Access Compliance Report

Public Rights-of-Way

(Curb Ramps)

Intersection ID: 4473	Main Street: SILVER_GLEN_LN	Cross Street: KILBRIDGE_WOODS_CT	Location: S
ADA ID: 2DEC5C8E274A	Ramp Type: Perp	Initial Pass/Fail: Fail	Overall Compliance: No
Severity Score: 8.75			
Codes/Mitigation Info/Possible Solution		Field Measurements/Component Compliance

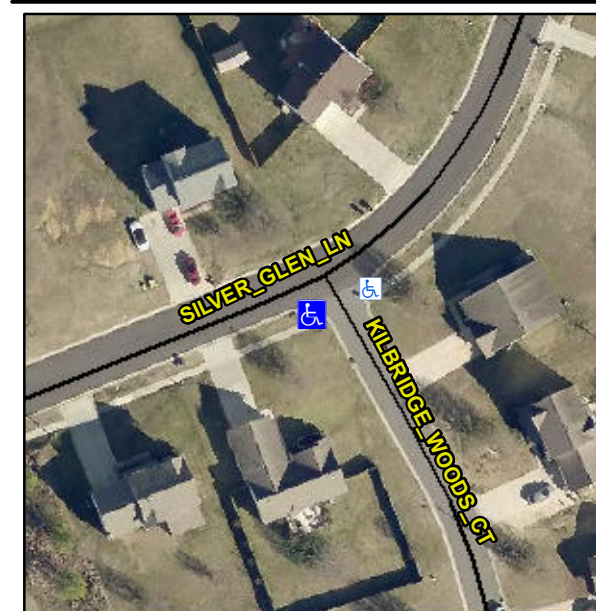
Compliance	Description	Data	Compliance	Description	Data
N/A	Ramp Length (in)	61.0	Yes	Ramp Slope (%)	7.4
No	Ramp Width (in)	47.0	Yes	Ramp XSlope (%)	0.3
N/A	Flare Type LT	N/A	N/A	Flare Type RT	N/A
N/A	Flare Slope LT (%)	N/A	N/A	Flare Slope RT (%)	N/A
N/A	Flare Traversable LT?	N/A	N/A	Flare Traversable RT?	N/A
N/A	Landing Length (in)	N/A	N/A	DWS Provided?	N/A
N/A	Landing Width (in)	N/A	N/A	DWS Contrast?	N/A
N/A	Landing Slope (%)	N/A	N/A	DWS Length (in)	N/A
N/A	Landing X Slope (%)	N/A	N/A	DWS Full Width?	N/A
N/A	Landing Curb? (Y/N)	N/A	N/A	DWS Offset (in)	N/A
N/A	Shared Landing?	N/A			
N/A	Gutter Ponding?	N/A	N/A	Gutter Slope (%)	N/A
N/A	Gutter Lip Ht (in)	N/A	N/A	Gutter X Slope (%)	N/A
N/A	Painted X Walk1?	No	N/A	Painted X Walk2?	N/A
	X Walk 1 Direction	To NE		X Walk 2 Direction	N/A
N/A	X Walk 1 Width (in)	N/A	N/A	X Walk 2 Width (in)	N/A
	X Walk 1 Slope (%)	1.7		X Walk 2 Slope (%)	N/A
	X Walk 1 X Slope (%)	1.1		X Walk 2 X Slope (%)	N/A

Remove & Replace Entire Ramp.
